**Mitigated Negative Declaration for the Proposed Street Light
Replacement for Areas 3–5B Project
City of Riverside**

**City of Riverside
Community & Economic Development Department
Planning Division**

P-3 COMMENTS AND RESPONSES TO COMMENTS

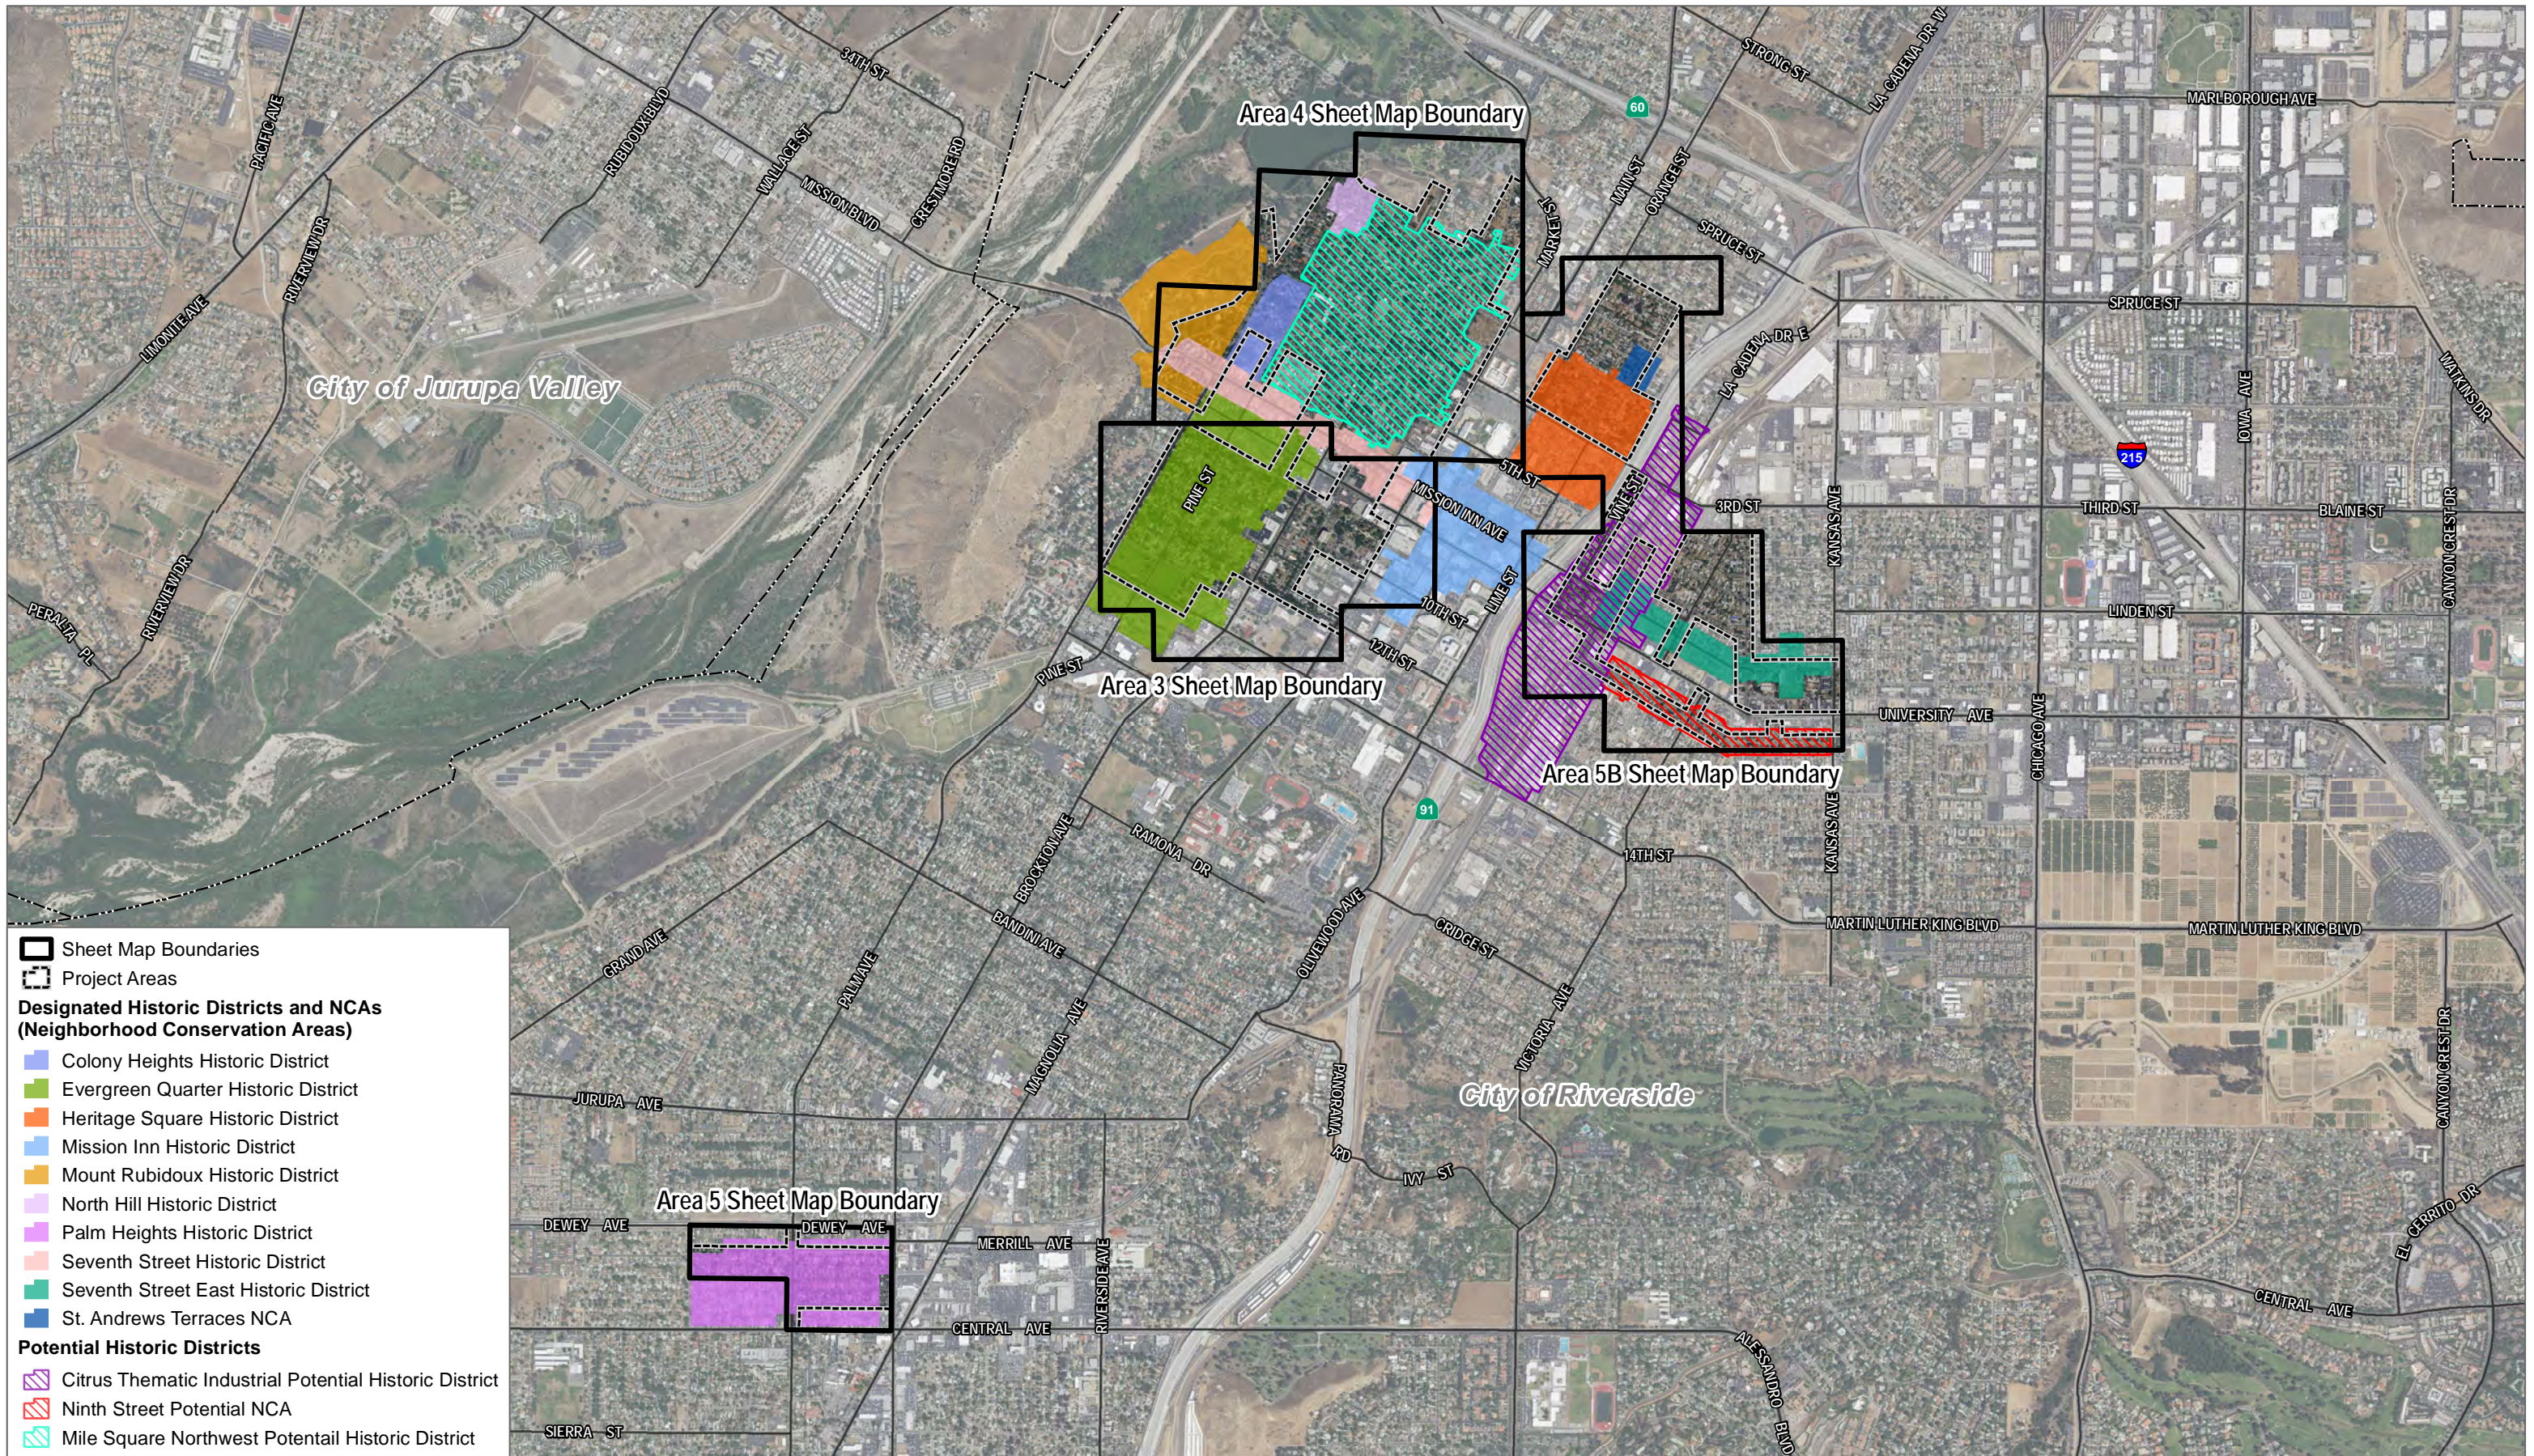
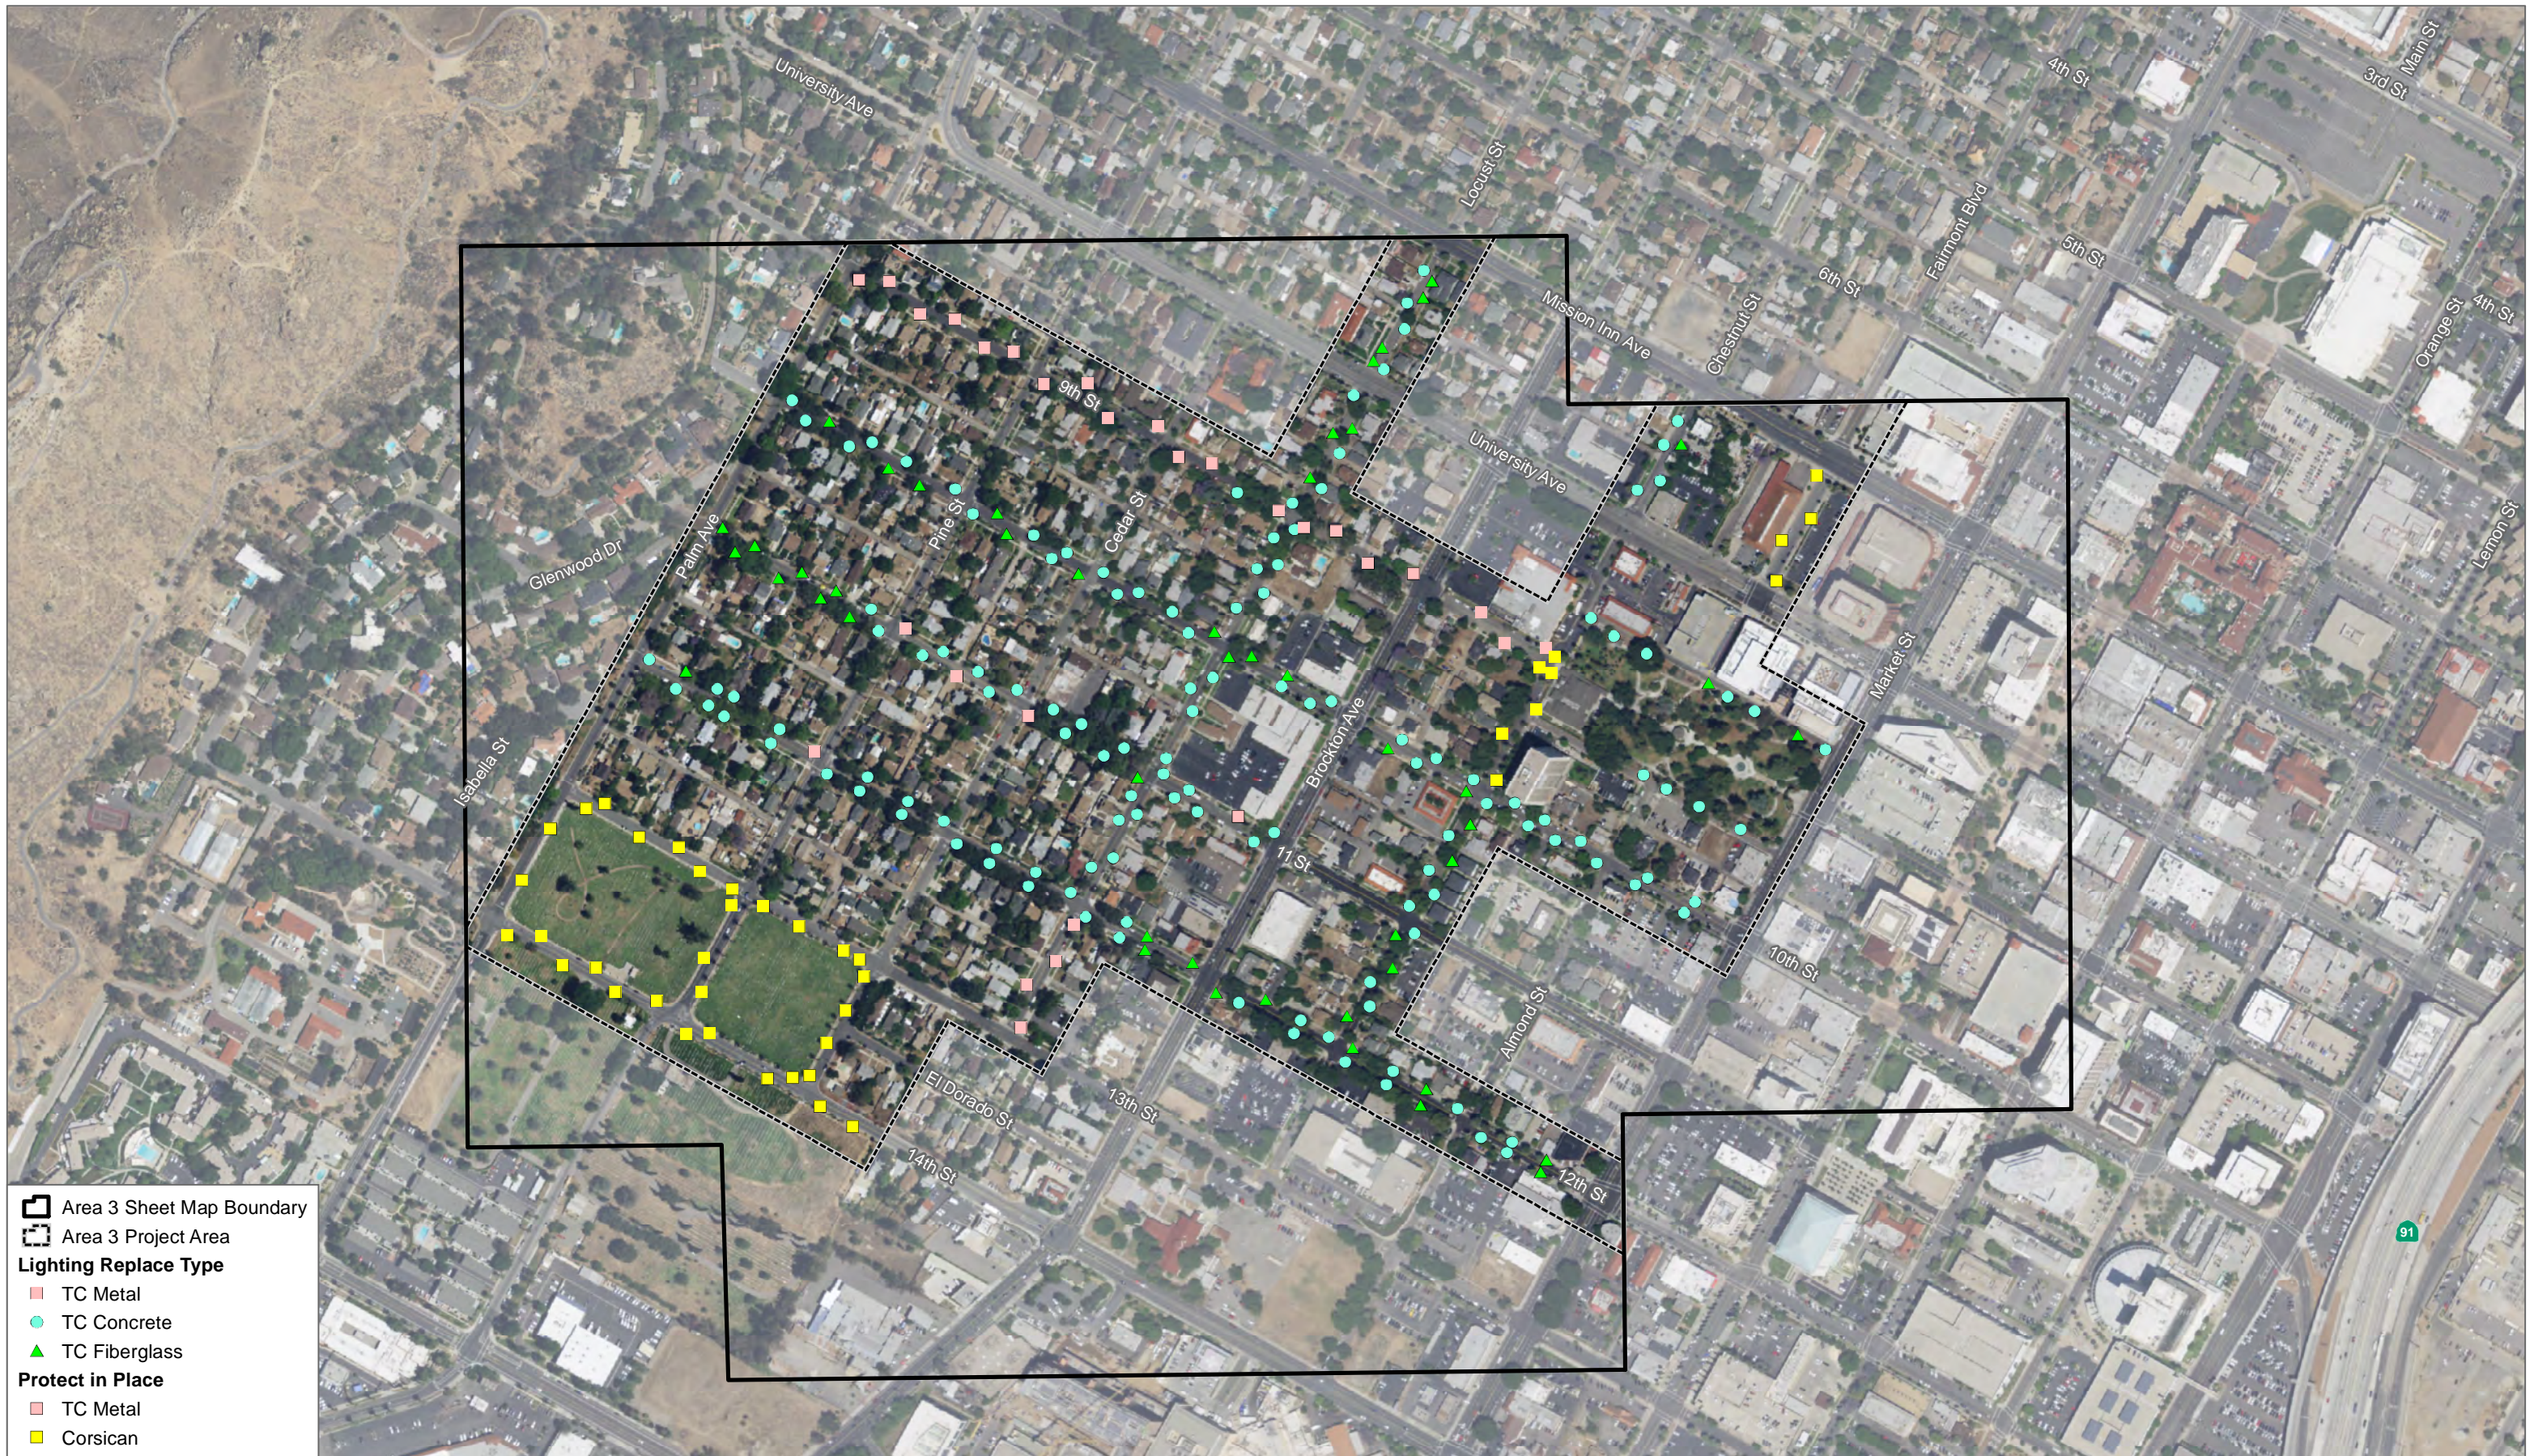
- A-1** The commenter expresses concern regarding the height and location of the proposed streetlights, and potential impacts this may have on airplane hazards. Figures 3 through 7, included in the IS/MND, show all locations where the streetlights would be replaced. As discussed in IS/MND Section 4.2.5a, the proposed number and spacing of streetlights is based on American National Standard Practice for Roadway Lighting ANSI/IESNA RP-8 (RP-8), the standard approved by the Riverside City Council in 1996. As advances in lumen output technology have been made since installation of the existing historic streetlights, RP-8 Standards would actually reduce the number of streetlights needed per block to provide required lighting levels. Thus, the proposed project is expected to result in fewer streetlights than currently exist in Areas 3 through 5B. Provisions of the City's historic preservation ordinance, Title 20, the Secretary of the Interior's Standards for the Treatment of Historic Properties related to historic resources and design standards and guidelines, require that replacement streetlights look similar to existing ones. Thus, it is expected that replacement streetlights would be similar in height to existing streetlights. More specifically, the design details of the proposed replacement streetlights, including the proposed height of the streetlights, have been incorporated as Figure P-1, Replica Kodiak Replacement Streetlights Details, and the design details of the proposed luminaires have been included as Figure P-2, Proposed Luminaire Details. As shown in these figures, the standard and luminaire, together, indicate a total installed height of 14 feet and 3.5 inches. It should be noted that the height of the proposed replica streetlights is approximately 2 inches taller than existing streetlights. However, the existing direct embedment historic streetlights currently vary in height for a variety of reasons, such as the depth of the original excavation at the time of installation, soil compaction, minor changes in parkway elevation due to landscaping changes, settlement, and intrusion by tree roots. It should also be noted that although not all the streetlights would be replaced in the exact same location as the existing streetlights, replacements would be made in the same general locations (either adjacent to or across the street from existing streetlights). Further, the proposed streetlights are not expected to exceed the heights of other structures in the areas, including two- to three-story existing structures in the area, telephone poles, palm trees, etc. Lastly, as discussed in Section 4.2.8d, although part of the project site is located within Compatibility Zone "Other Airport Environs" of the Riverside Municipal Airport, only uses that would be hazardous to flight (such as tall structures) are prohibited within this zone.. The City provided additional information regarding the height and location of the proposed streetlights to the commenter on October 3, 2018, and November 1, 2018.
